PREPARED FOR THE URBAN DESIGN COMMISSION AND PLAN COMMISSION

**Project Address:** 22 South Carroll Street (4<sup>th</sup> Aldermanic District, Alder Verveer)  
**Application Type:** Conditional Use  
**Legistar File ID #:** [36301](#)  
**Prepared By:** Heather Stouder, AICP, Planning Division  
Report Includes Comments from other City Agencies, as noted

**Requested Action:** Approval of a conditional use to exceed the Capitol View Height Limit in conjunction with a significant remodeling and an addition to an existing hotel in the Downtown Core (DC) District.

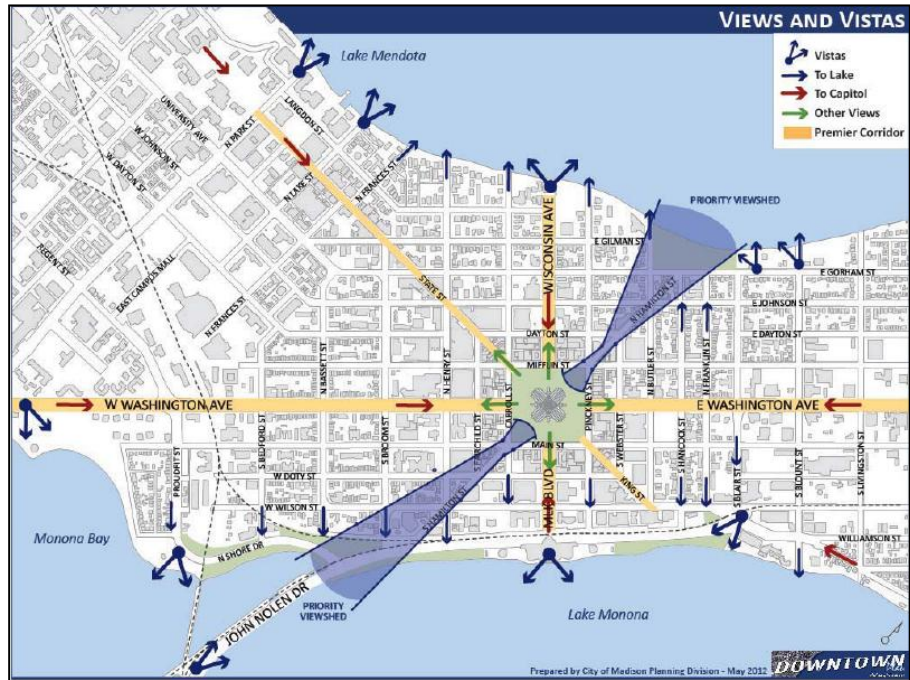
The rounding of the ninth floor corner removes a small amount of the existing building from the South Hamilton Street View Corridor to and from the Capitol Building, which is identified in the Downtown Plan as a priority viewshed (see map at right).

This change helps to meet Objective 3.1 in the Plan, “Preserve Views of, to, and from the Downtown that reflect the natural topography and enhance views of the skyline, Capitol, lakes, and other important vistas.”
